Item 4.1 DA 2018/90 99 - High Street & 6 Mill Lane, Oatlands

Additional Information from ERA Planning

Attention: Jacqui Tyson, Senior Planning Officer

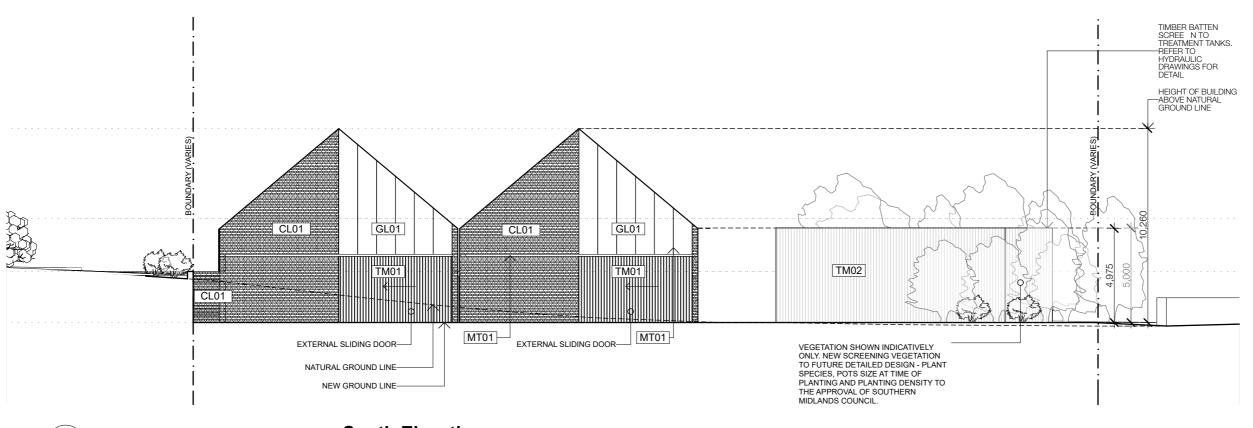
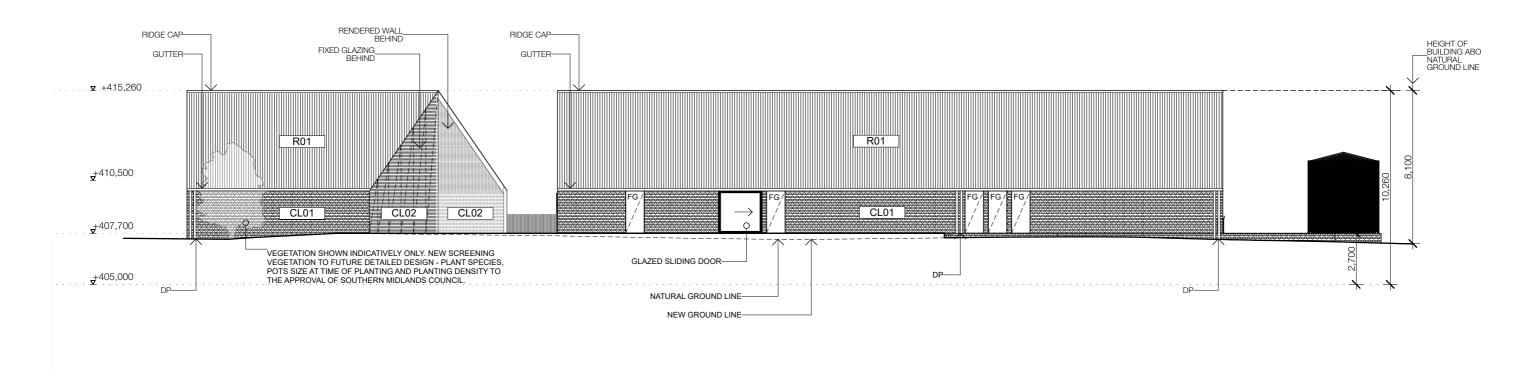
- a) View 09 in the Architectural report refers to Millers Lane rather than Mill Lane. Please provide a corrected version.
- b) Please provide an amended plan of South elevation (Drawing T17333-da08 Issue B) identifying all external materials for clarity.

Please see attached Appendix A_Architectural Report & Proposal Plans (Revised), which addresses the above request and supersedes the original Appendix A submitted with the application.
